SUBJECT: Forwards info re recently discovered error that impacts validity of TS limit issued in 920507 Cycle 7 reload amend. Proceeding above 25% rated thermal power on 920517 is safe & justified.

SUSQUEHANNA STEAM ELECTRIC STATION
ADMINISTRATIVE CONTROL OF FLOW DEPENDENT
MCPR OPERATING LIMITS FOR UIC7 OPERATION
PLA-3778 FILES A17-2, R41-2

Docket No. 50-387

Total Core Flow (% OF RATED)
FLOW DEPENDENT MCPR OPERATING LIMIT.
FIGURE 3.2.3-1

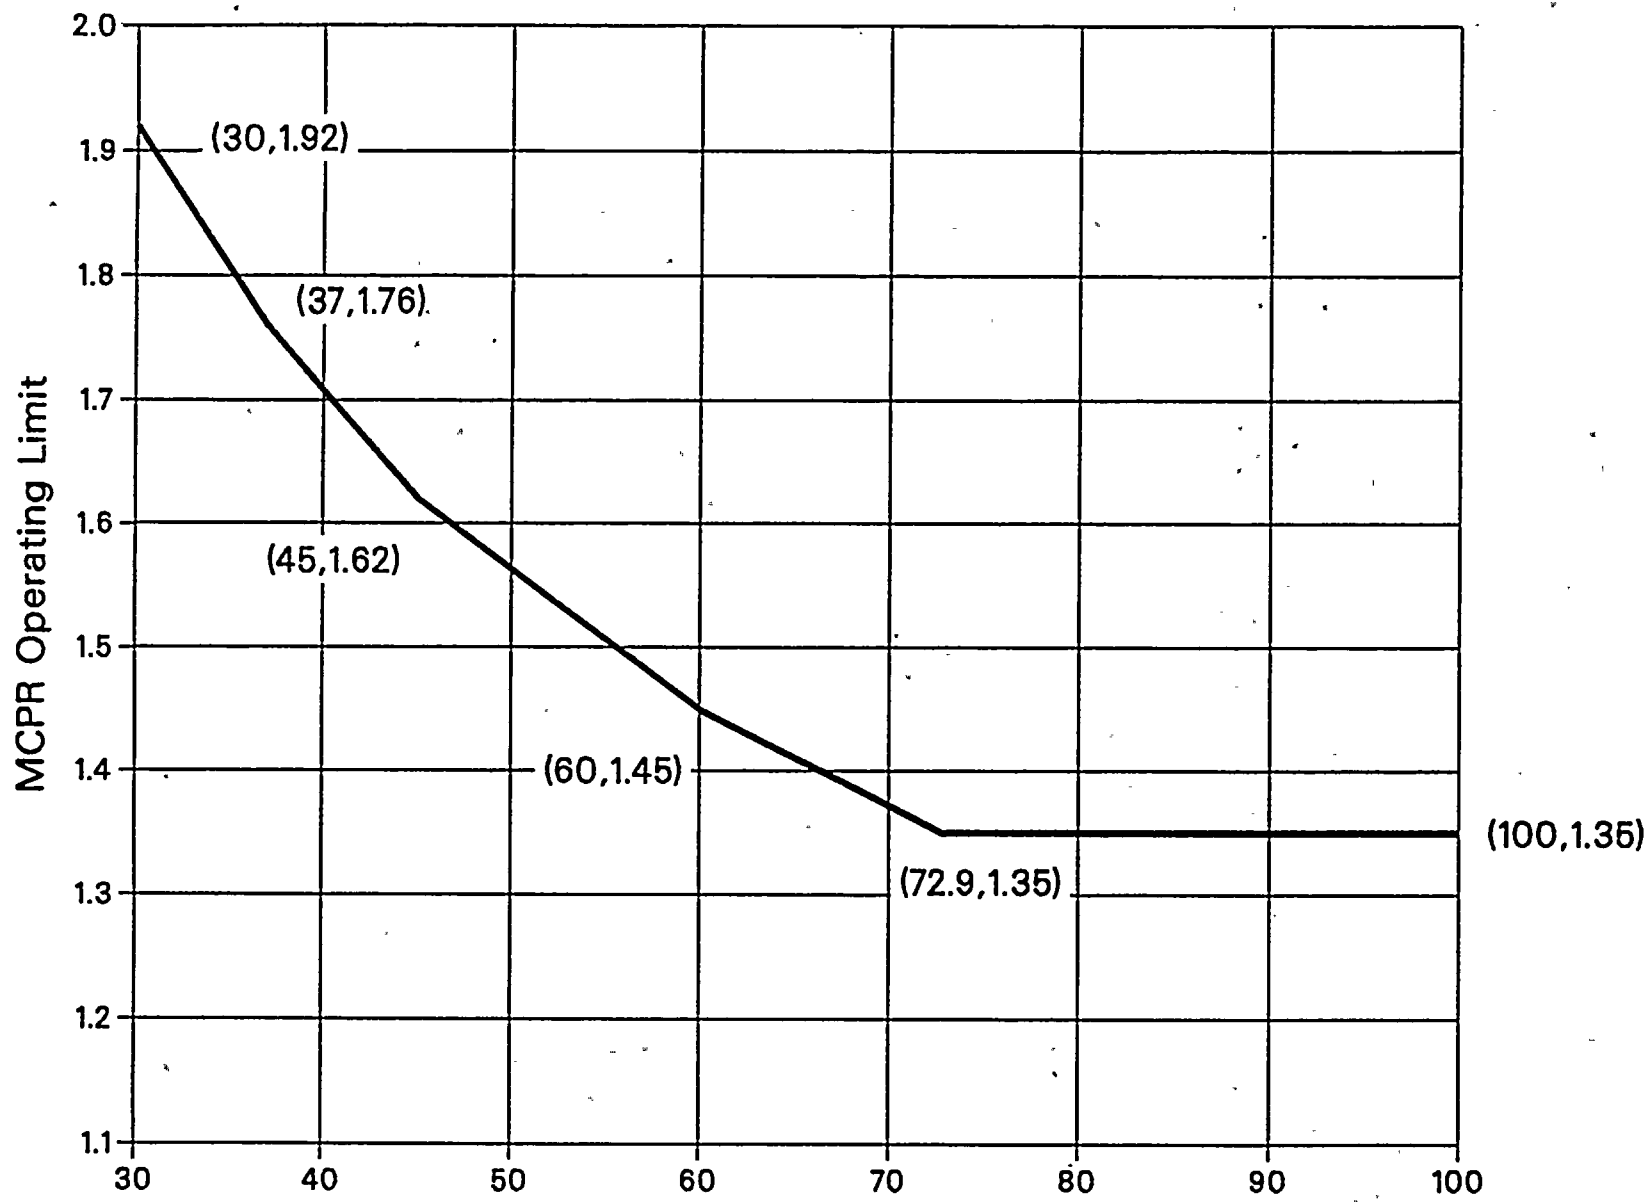
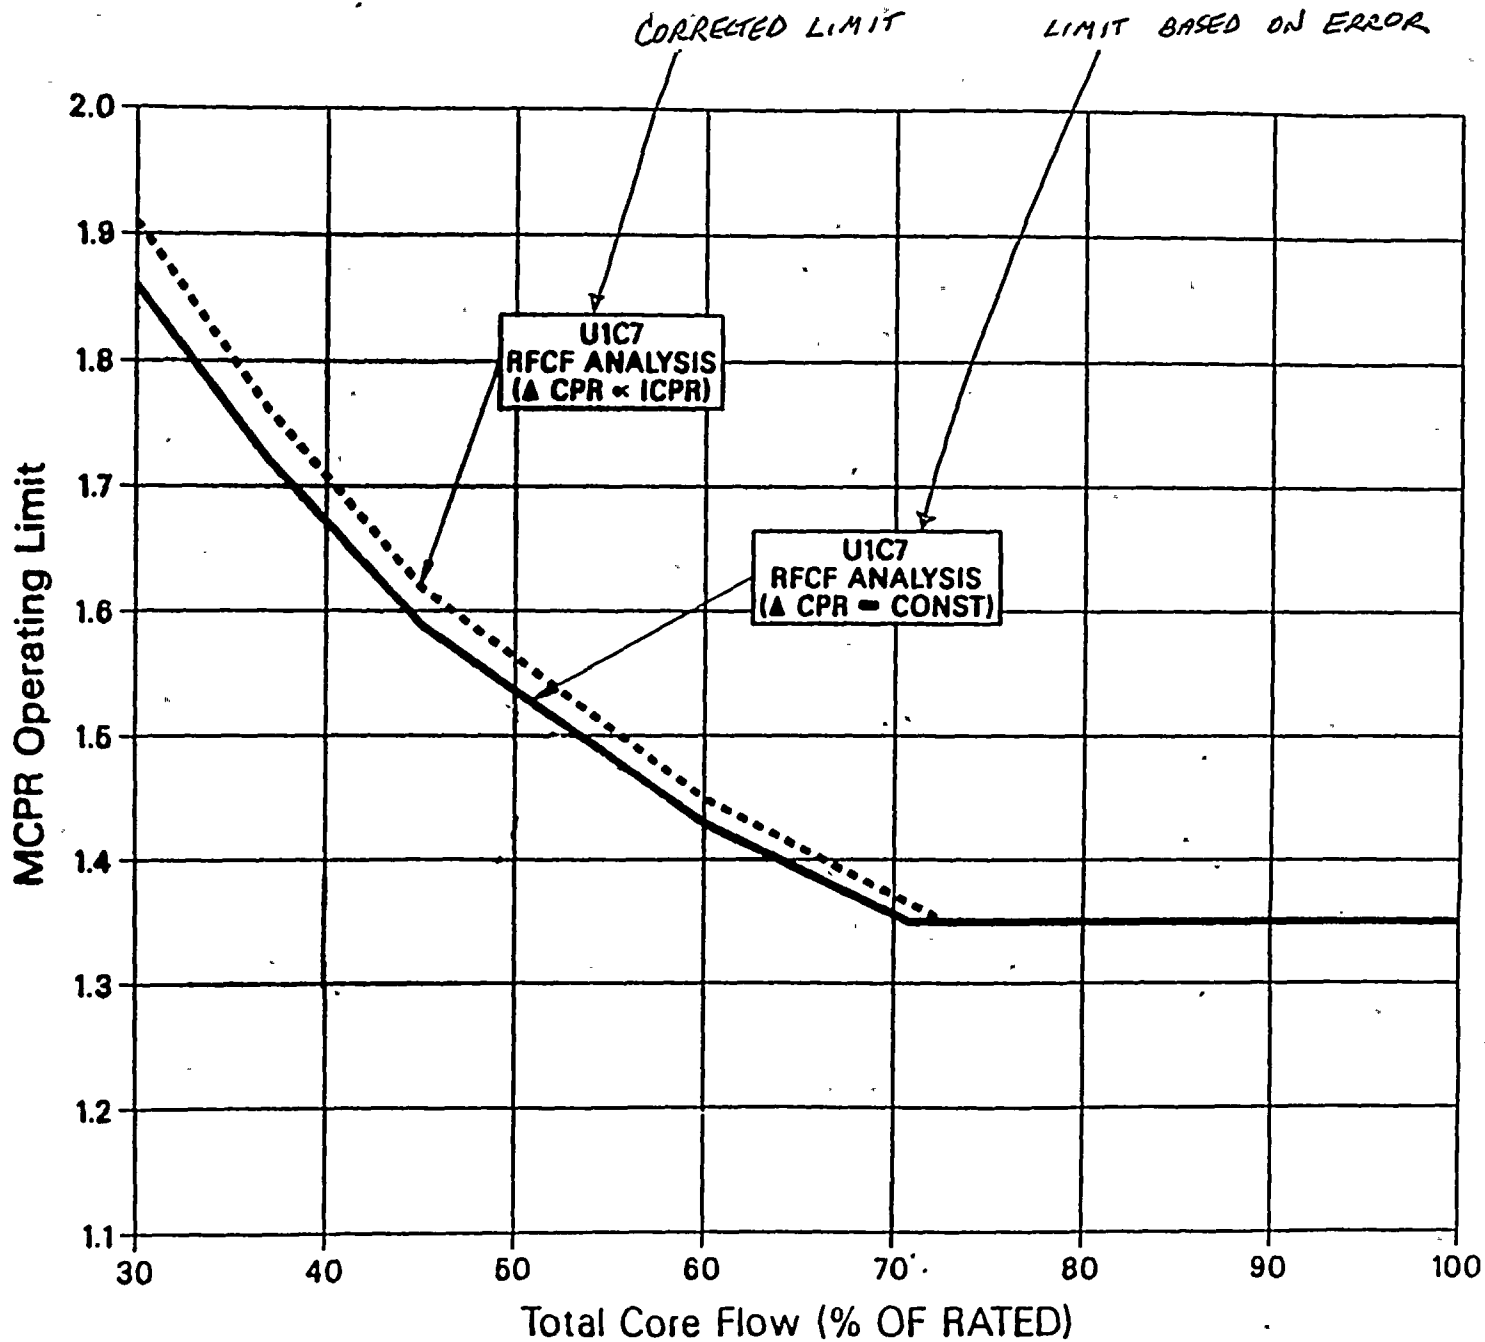
On May 6, 1992, during final independent review of the Unit 2 Cycle 6 (U2C6) reload licensing analysis packages, an error was discovered in the calculation of the Technical Specification flow-dependent MCPR operating limit curve (Figure 3.2.3-1). This error will be corrected for U2C6 prior to submitting the proposed reload amendment to the NRC. The flow-dependent MCPR operating limits curve derived for UIC7 was subsequently checked and found to contain the same error. The following paragraphs describe the basis for the flow-dependent MCPR operating limit curve, the nature of the calculational error, an assessment of safety impact, and PP&L's proposed corrective actions (including compensatory actions) to resolve this problem.

The analyses of the RFCF for U1C7 were performed using the methodology described in PP&L's NRC-approved licensing topical reports. An error was discovered in the calculation of the flow-dependent MCPR operating limit curve. More specifically, the error involves the equation used to compute the delta-CPR from which the MCPR operating limit is derived. The transient hot bundle delta-CPR is calculated based on reaching a minimum CPR equal to 1.0. PP&L's methodology requires that a 4% uncertainty (i.e., 1.04 factor) be applied to the relative change in CPR ($RCPR = \text{delta CPR}/\text{initial CPR}$). From the adjusted RCPR, the final delta-CPR is calculated and added to the MCPR Safety Limit (equal to 1.06). However, analyses show that a transient initiated from a higher initial MCPR results in a higher value of calculated delta-CPR, compared to the identical transient initiated from a lower initial MCPR. This aspect of the delta-CPR calculation was omitted in the calculation for U1C7. Therefore, relative to PP&L's defined methodology, the flow-dependent MCPR operating limit for U1C7 was calculated incorrectly, and resulted in an incorrect Technical Specification *Figure 3.2.3-1* being transmitted to and subsequently approved by the NRC. Pertinent portions of the hand calculation found to be in error are attached for your information.

A new flow-dependent MCPR operating limit curve has been prepared, based on correcting the described error such that the new curve is what PP&L should have originally supplied to the NRC, and what the NRC believed they approved via the reference. Copies of the new curve, the old and new curve together, and the numbers that form the basis for the old and new curves are attached.

The new curve has been entered into PP&L's Powerplex core monitoring system, and as such will be enforced as the proper Technical Specification operating limits. PP&L will operate under these limits administratively until such time as a formal Technical Specification change can be processed. PP&L will submit this change by May 22, 1992, but it is understood that our commitment to the above administrative controls will serve to safely control plant operation until such time as the NRC formally approves the change.

CORRECTED FIGURE
